October 8, 1999  
JPN-99-033

Subject: James A. FitzPatrick Nuclear Power Plant  
Docket No. 50-333  
Response to questions from a 7/12/99 NRC facsimile to the  
Authority, Re: James A. FitzPatrick USI A-46 program

**Response to questions from the July 12, 1999 facsimile from the  
Nuclear Regulatory Commission regarding the J. A. FitzPatrick  
Nuclear Power Plant USI A-46 program**

Figure 1  
Comparison of the response spectrum of the input ground motion time history vs. the Housner correlation spectrum anchored at 0.15g.

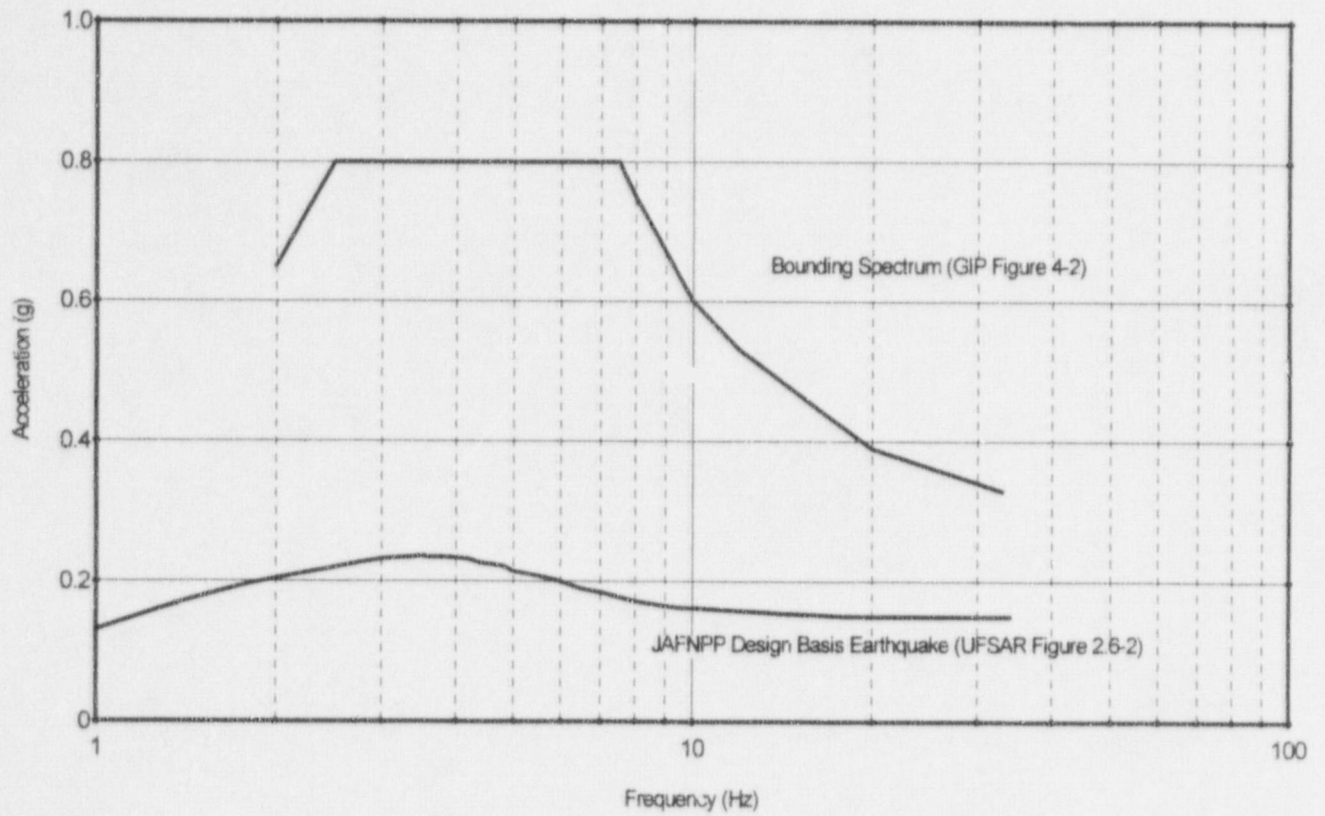
Is the ground spectrum of the time history used as the input to the model to generate the IRS at various elevations significantly higher than the Design Basis Earthquake ground motion which is characterized by the Housner design response spectrum normalized to a peak ground acceleration of 0.15g? If the answer is yes, provide a plot of the 5 percent critical damping response spectrum of the ground motion time history.

The response spectrum of the input ground motion time history entirely envelops the Housner design spectrum anchored at 0.15g. It significantly envelops the Housner spectrum at frequencies below 5 Hz and more closely follows the Housner acceleration amplitudes at frequencies greater than 5 Hz. Figure 1 is excerpted from an original plant design calculation (Reference 5) performed by Stone & Webster and shows the comparison for 0.5% damping. A plot does not exist comparing the spectra at a 5% damping value.

Figure 1 shows a plot of the 0.5% damped response spectrum from the time history and the FitzPatrick licensing basis ground response spectrum. The time history spectrum conservatively envelopes the licensing basis free field spectrum in the frequency range of 1 to 5 Hz. Above 5 Hz, the time history spectrum is close to the licensing basis free field spectrum. For each structure, the degree of conservatism in the ISRS depends on the structure's response frequency.

Figure 2  
 Licensing Basis Free Field Response Spectrum Compared to Bounding Spectrum  
 (Both curves 5% damped)

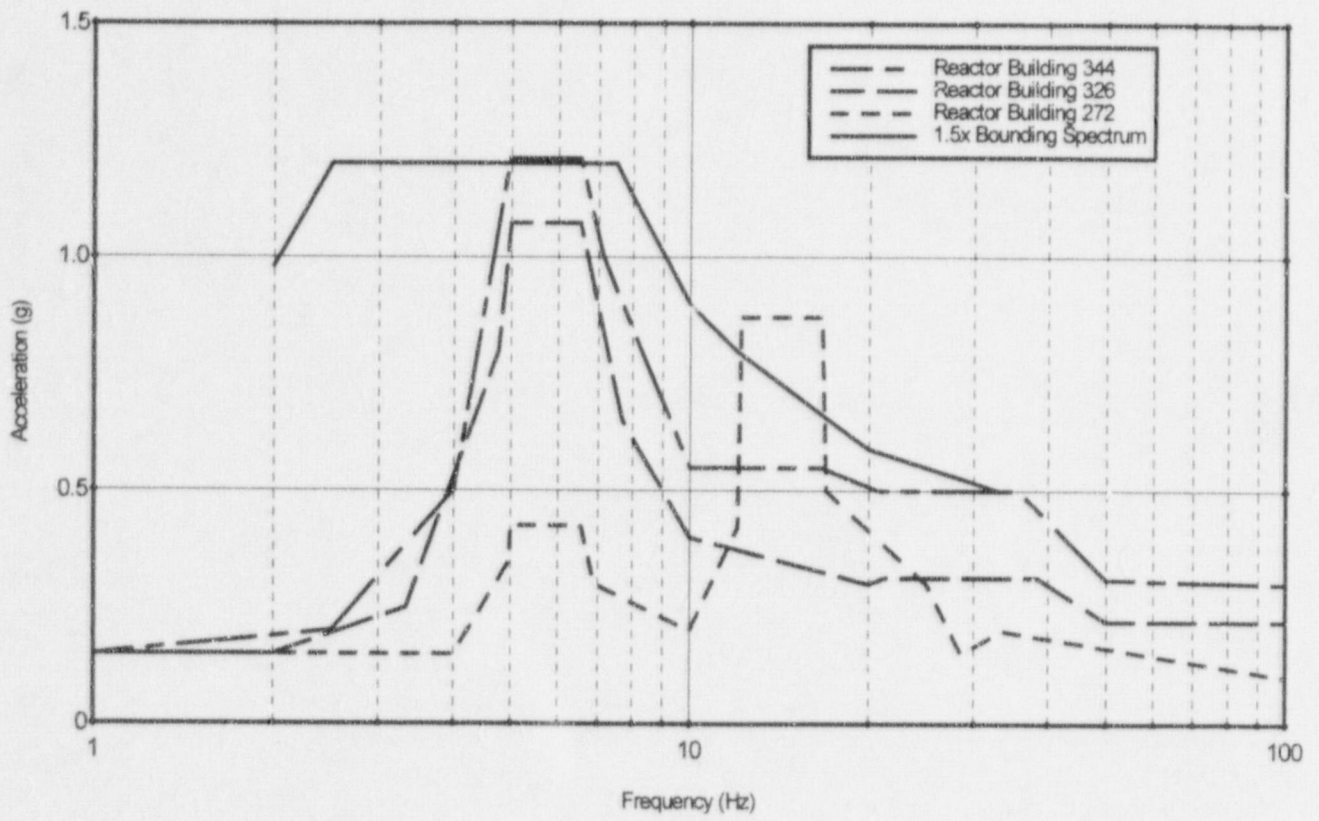
The Generic Implementation Procedure, Revision 2 (GIP-2) provides for several methods of comparing seismic capacity to seismic demand. Method A.1 compares the SQUG Bounding Spectrum to the plant's safe shutdown earthquake ground response spectrum. GIP-2 places limitations on the use of Method A.1. These limitations are that

In Figures 3.1 and 3.2 FitzPatrick USI A-46 Final Report NYPA presents plots of the envelope of the turbine building IRS at elevations 272 feet and 300 feet and reactor building IRS for elevations 272 feet, 326 feet and 344 feet, respectively. The amplification factors, above 8 Hz, of some of these IRS for elevations where Method A.1 was used appear to be significantly above the 1.5 limit set by GIP-2. Provide a building specific justification for the use of Method A.1 at the locations where the amplification significantly exceeds the 1.5 limit above 8 Hz.

The FitzPatrick site is a rock site. The buildings are founded on bedrock with a shear wave velocity exceeding 5500 ft/sec. During original plant construction, approximately 45 feet of the rock was excavated, and the plant structures were founded directly on the rock. The free field licensing basis ground spectrum is a Housner spectrum with a peak ground acceleration of 0.15g. Figure 2 shows the free field licensing basis ground spectrum compared to the SQUG bounding spectrum.
